**URGENT FIELD SAFETY NOTICE**

GEHC Ref# 32047

RE: Infant Warmer System (IWS) Hot "Heater Head" Screw could Fall onto the Bed

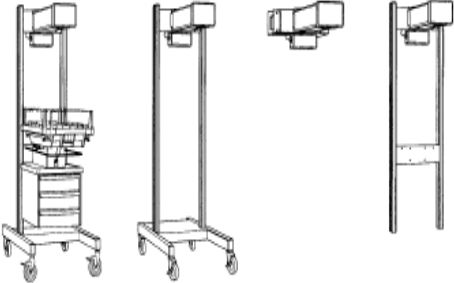
**Safety Issue** Hot screws from the "Heater Head" of the IWS could fall onto the bed if the "Heater Head" assembly has been improperly serviced. This situation can be clinically hazardous because thermal injury to a patient could result. Two injuries have been reported as a result of this issue.

**Safety Instructions** The potential for this issue to occur is only present if the "Heater Head" assembly has been improperly serviced.

As a result, if "Heater Head" service has been performed in the past, check to ensure that the screws are tightened as soon as the unit becomes available.

If the "Heater Head" assembly has not been serviced, check to ensure that the screws are tightened as part of your next regularly scheduled annual Preventive Maintenance check.

The attached Service Manual Addendum provides instructions for checking and tightening the screws. During each annual Preventive Maintenance check, continue to ensure that the screws are tight.
